May 3, 2006

MEMO TO: Mr. Keith Wilkins, Director, Neighborhood & Environmental Services Department
THRU: Mr. Doyle Butler, Chief, Environmental Quality Division
Mr. Timothy Day, Environmental Quality Division

SUBJECT: Perdido Key Dune: Final Status Report

Figure 5 - As Built profiles of Western Portion of EED, as measured, and the Design Template

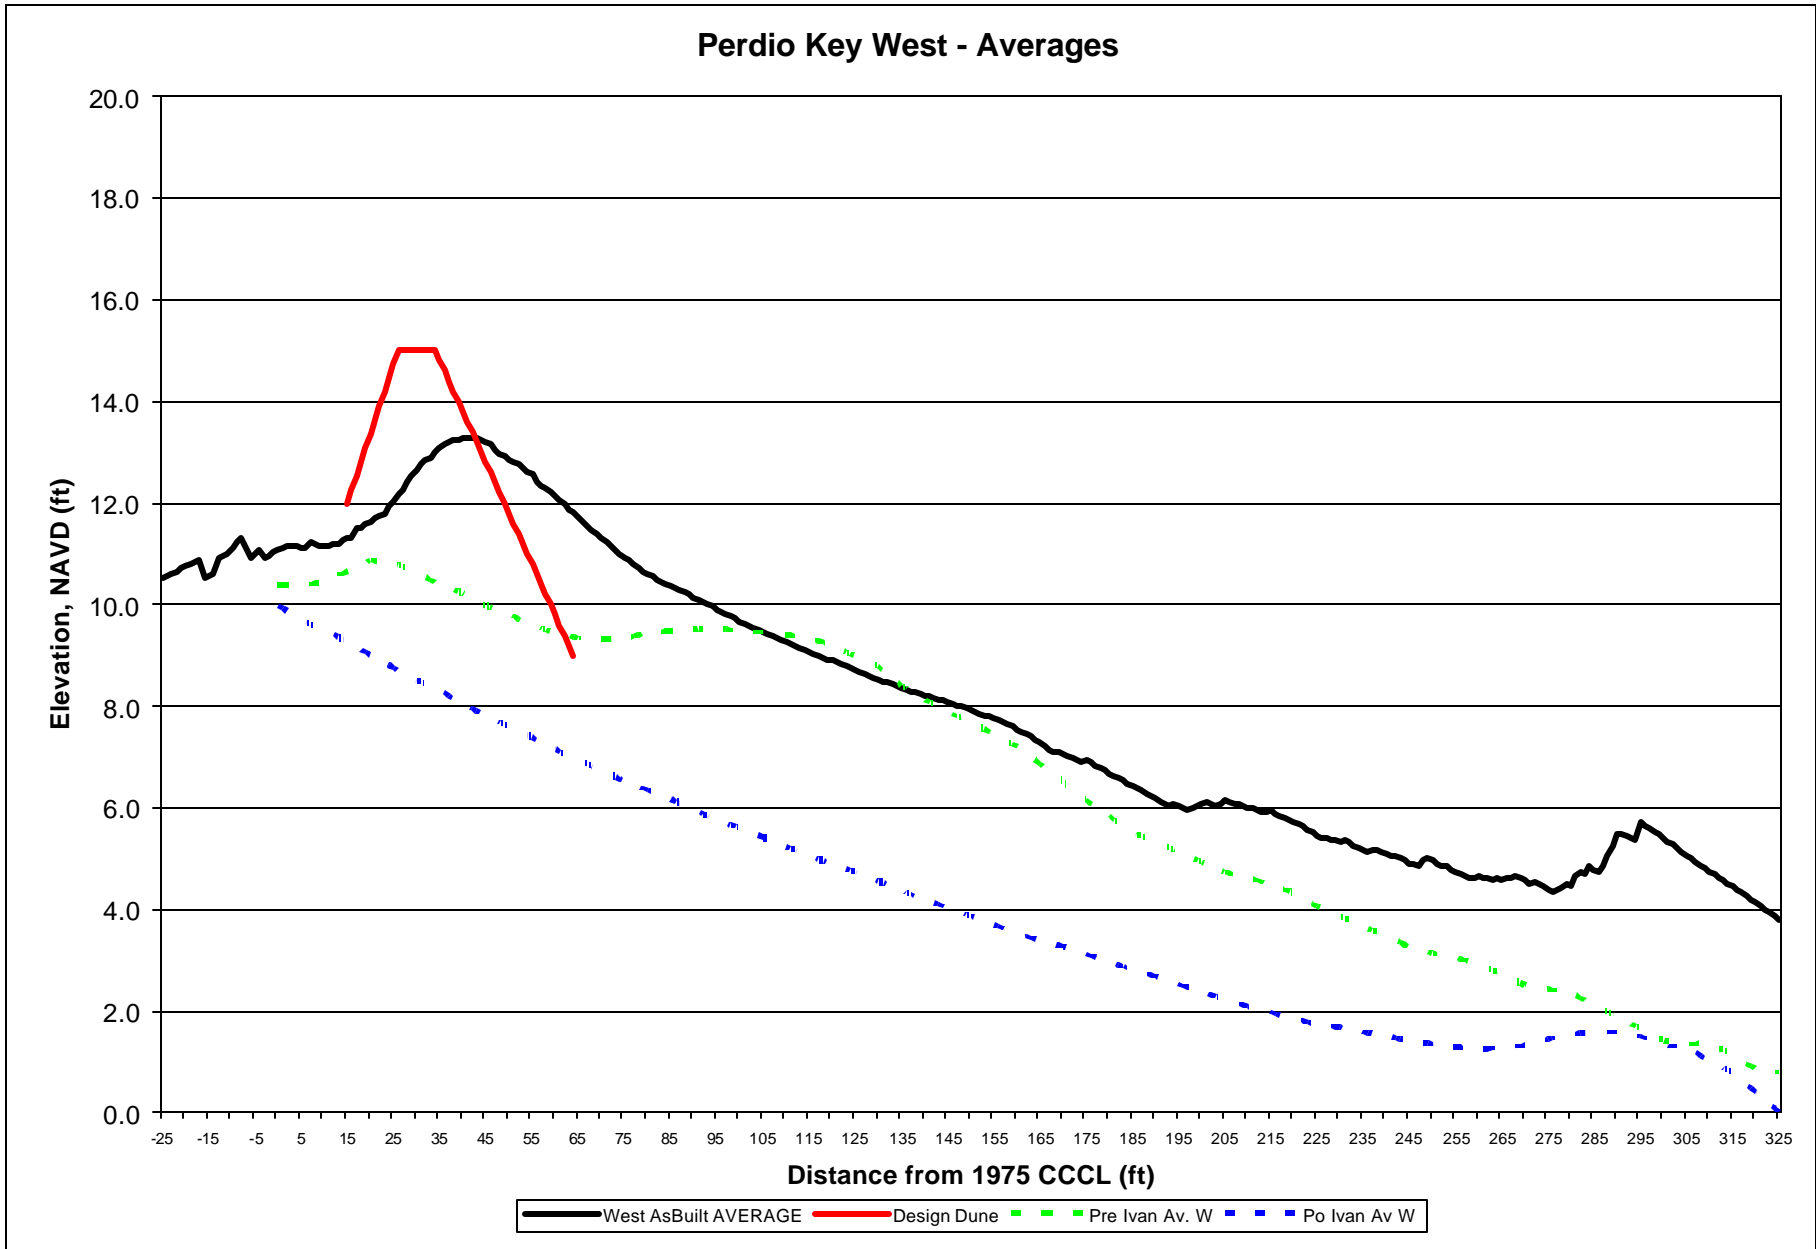
E. Figure 5 shows an overlay plot of all of the cross sections and the design template for the EED for the Western Portion of the Project. The dune on this portion also meanders significantly around its design position; only 7 out of 49 profiles, representing about 18 % of the Western Portion, have the north edge of the crest within ± 4 ft of the design location (26 ft south of the 1975 CCCL).

3. One exception to this general statement is the section from station 64 +00 to 66+00. Not only are these two profiles (see dashed lines on Figure 5) displaced 70' to 80' seaward, they are much steeper than other profiles both on the backshore and foreshore, and the + 3 ft contour moves 75 to 150 ft landward at this location compared to most of the rest of the Western Portion.

Figure 6 - Averages of the As Built EED, Pre and Post Ivan profiles, and the Design Template for the Western Portion of the Project

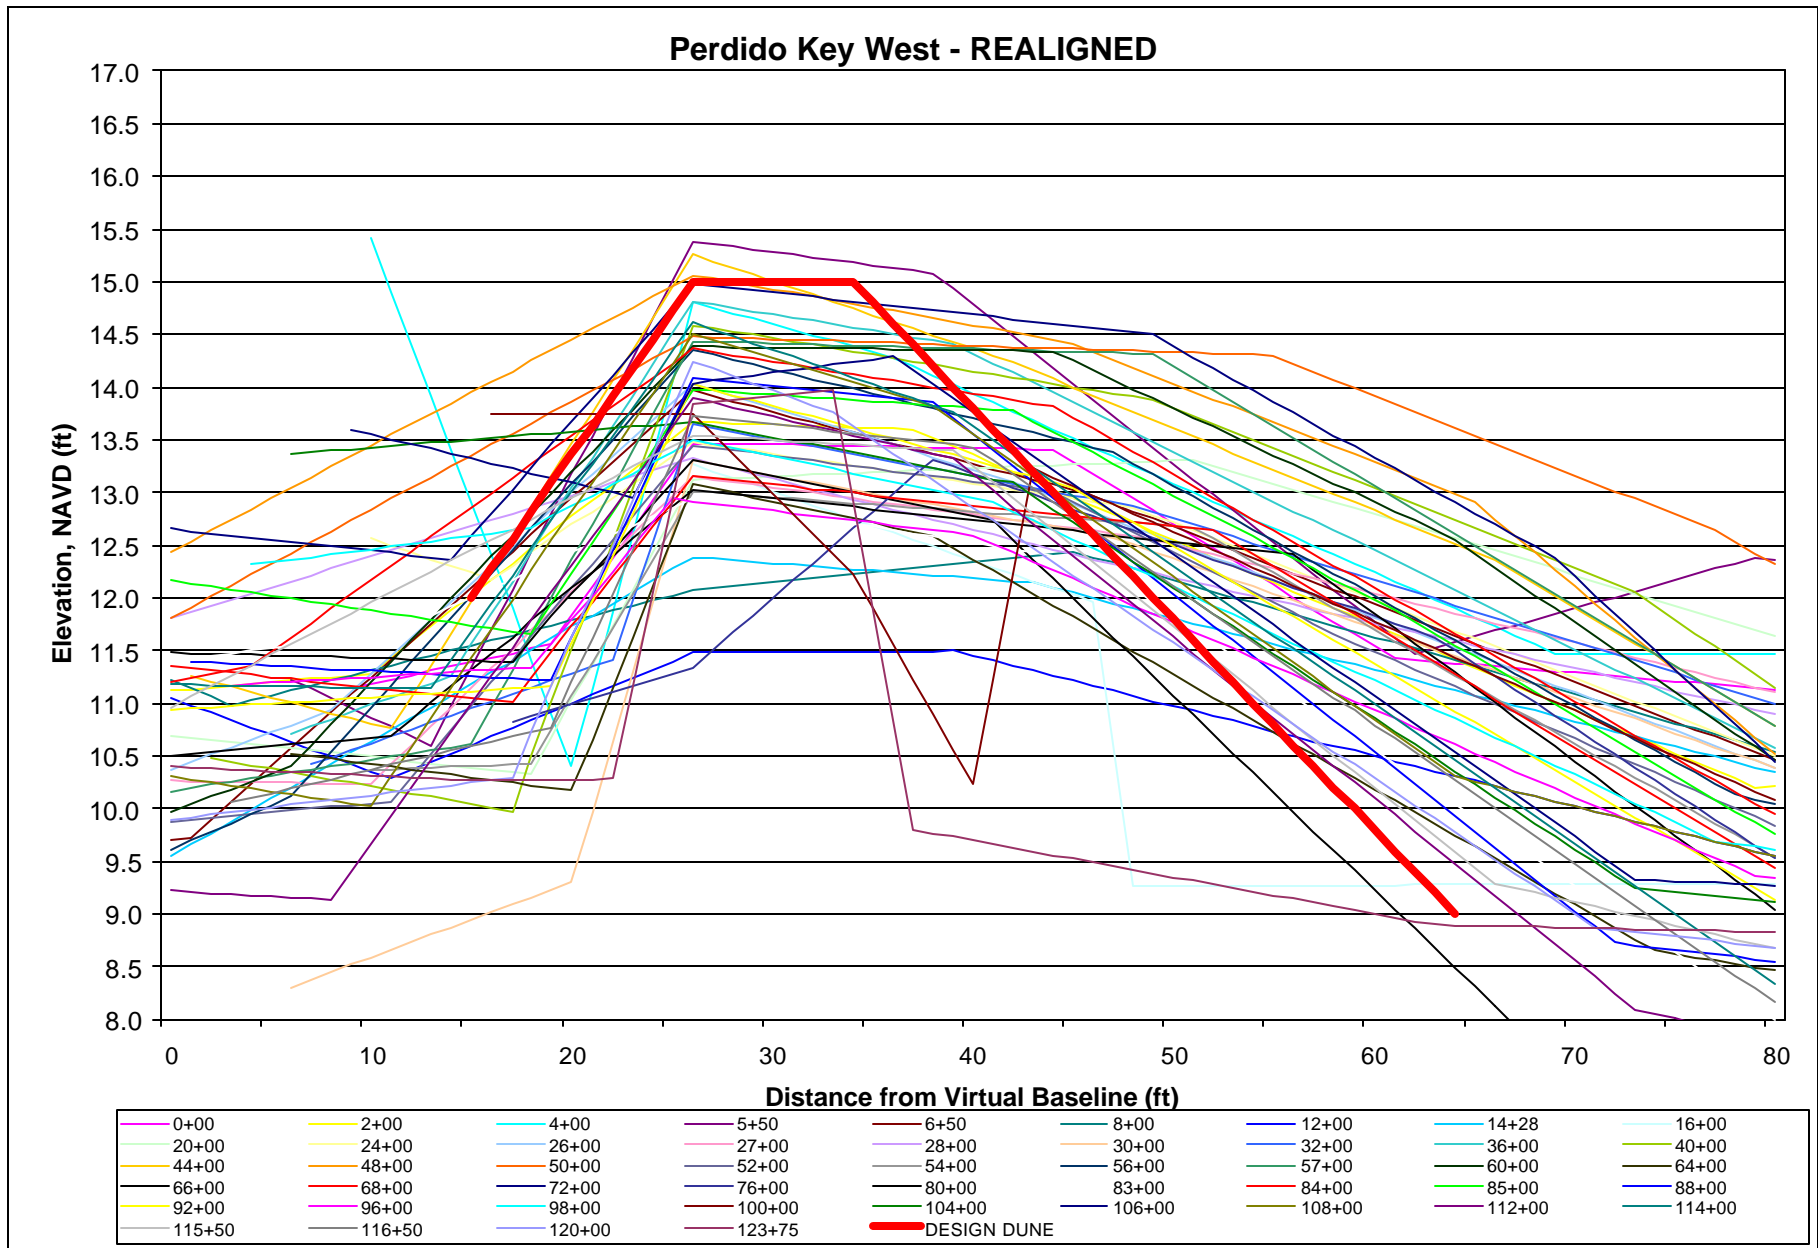
F. Figure 6 shows the average of all of the cross sections for the EED, the average pre and post Hurricane Ivan cross section, and the design template for the Western Portion of the Project. (There were insufficient post Hurricane Dennis cross sections collected from the western Portion to warrant inclusion.) In general, the entire profile is significantly higher than the pre Ivan condition. The crest of the average profile of the EED has a peak elevation near +13.3 ft NAVD, is about 8 ft wide, but is displaced 12 ft seaward from the design position.

Figure 7 - Realigned profiles of Western Portion of EED and the Design Template

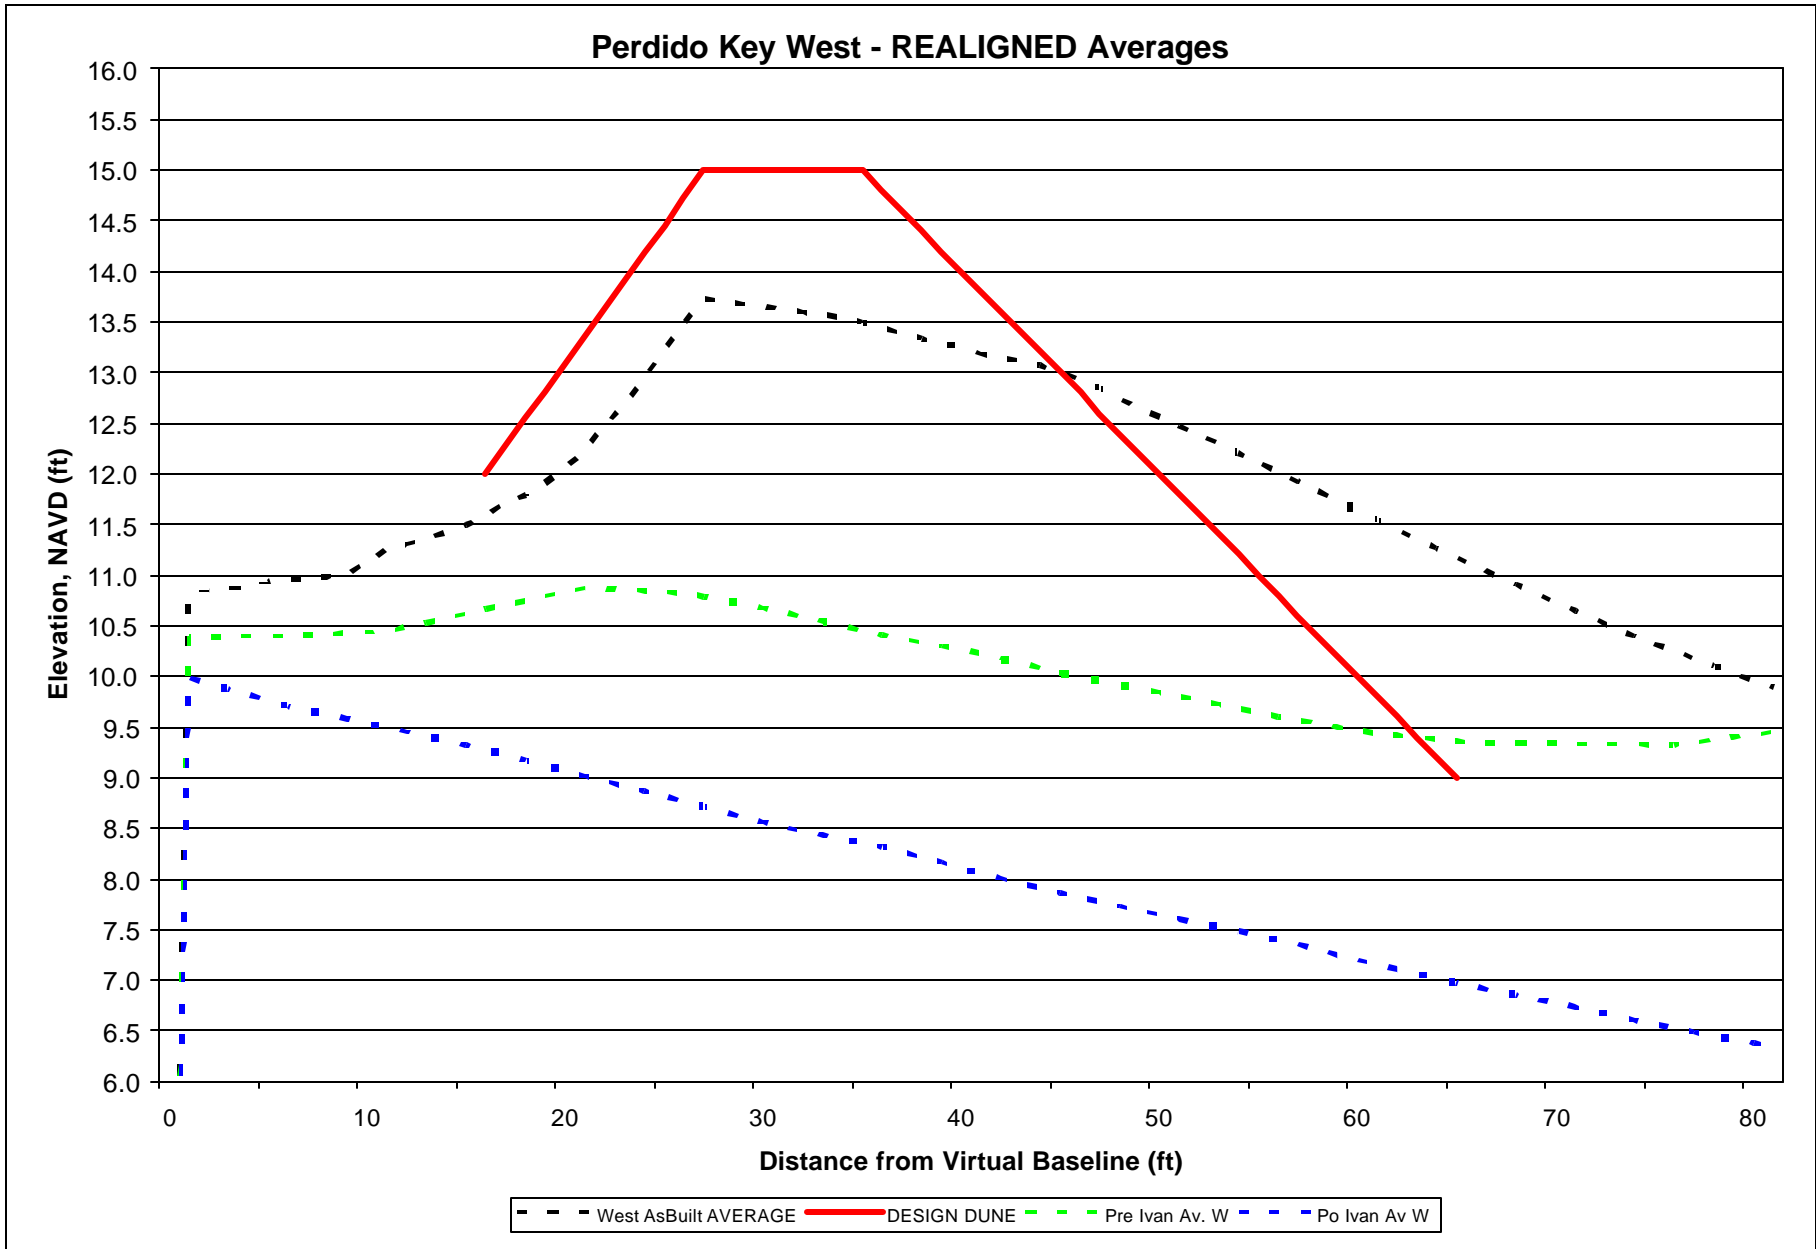
G. Figure 7 shows each profile of the Western Portion of the Project manually realigned to place the north edge of the crest at the design position in order to evaluate constructed dune shape, regardless of position, and the EED design template. It is obvious that most of the profiles are significantly lower and much wider than the design.

Figure 8 - Averages of the realigned EED profiles with Pre and Post Ivan, and the Design Template for the Western Portion of the Project

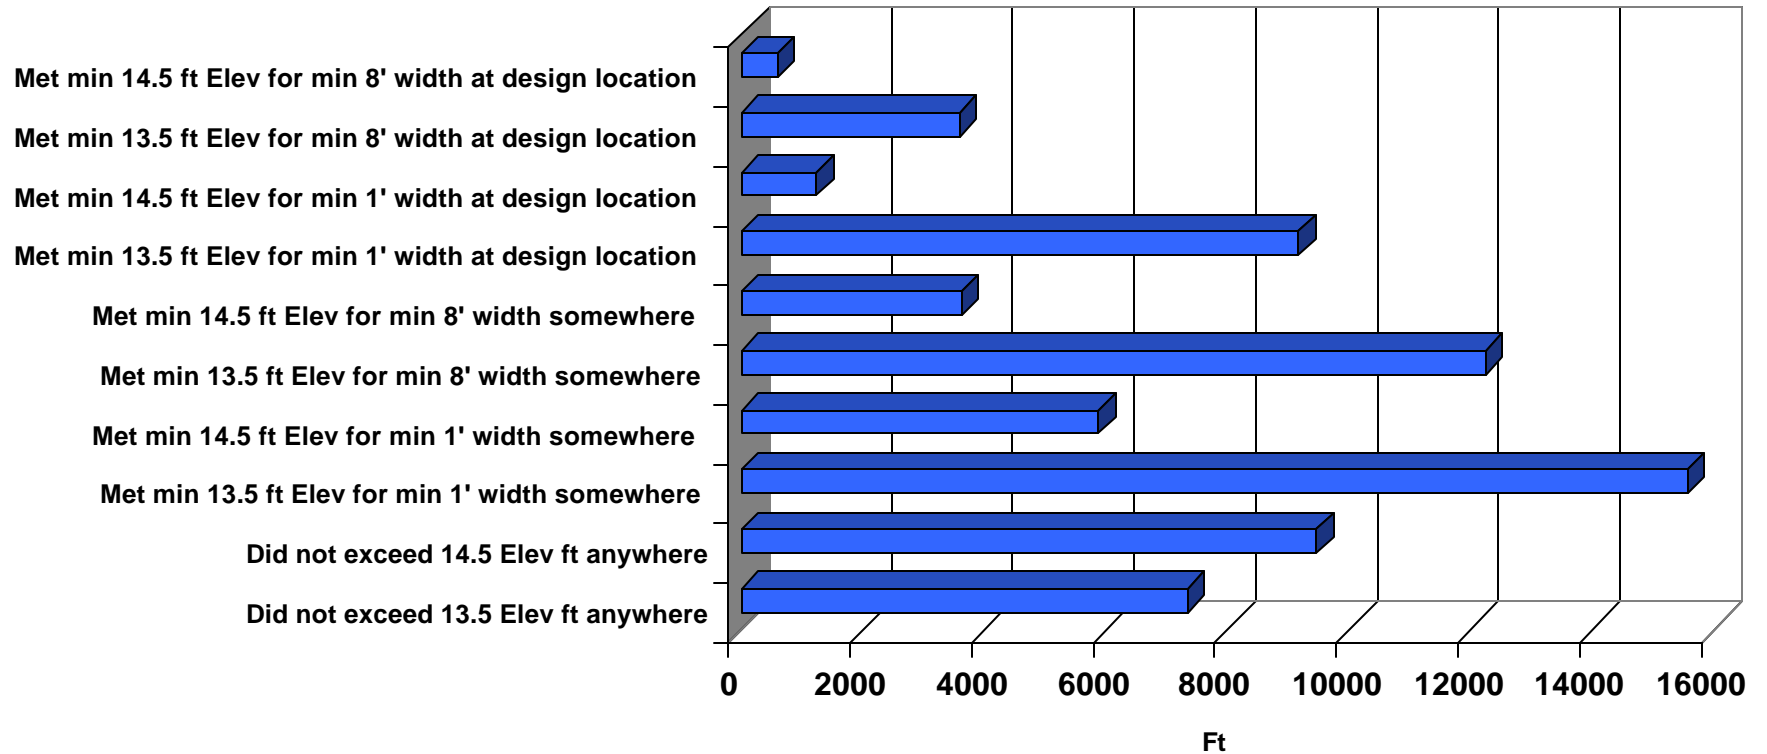
H. Figure 8 shows the average of all of the realigned cross sections for the EED, the average pre and post Hurricane Ivan cross section, the average post Hurricane Dennis cross section, and the design template for the Western Portion of the Project. The average crest elevation of the realigned dune is about + 13.6 ft NAVD (it slopes from + 13.7 ft at the north edge to + 13.5 ft at the design south, or seaward edge). The average foreslope is considerably flatter than the design.

Figure 9 – Conformance Criteria of As Built EED by length (ft)

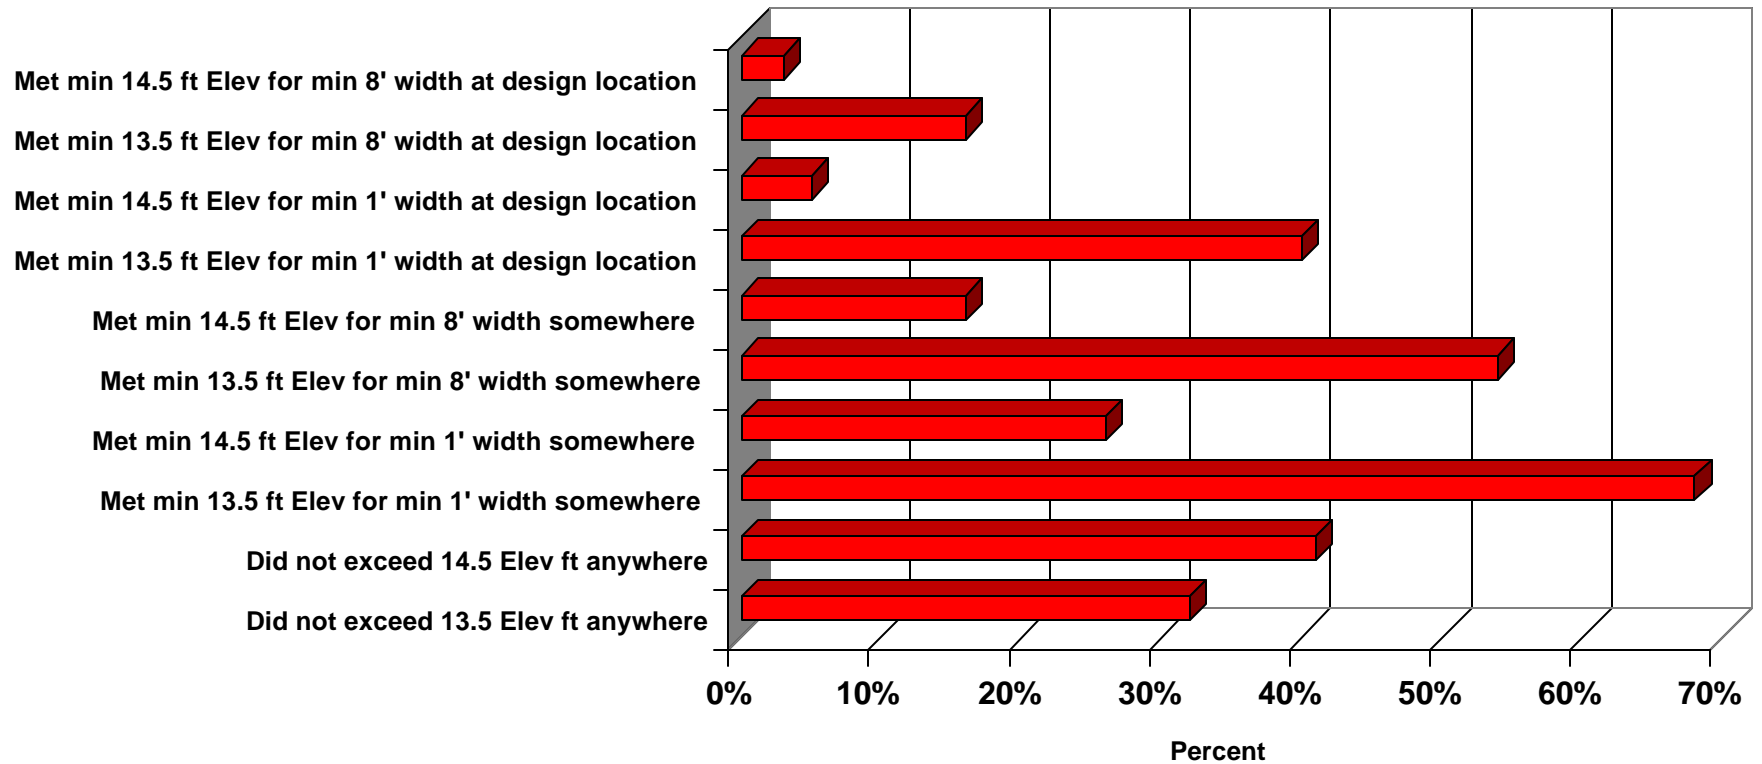
I. The overall conformance of the entire EED project (East and West Portions combined) with the design regarding 10 criteria is summarized in the Table below and in Figures 9 and 10.
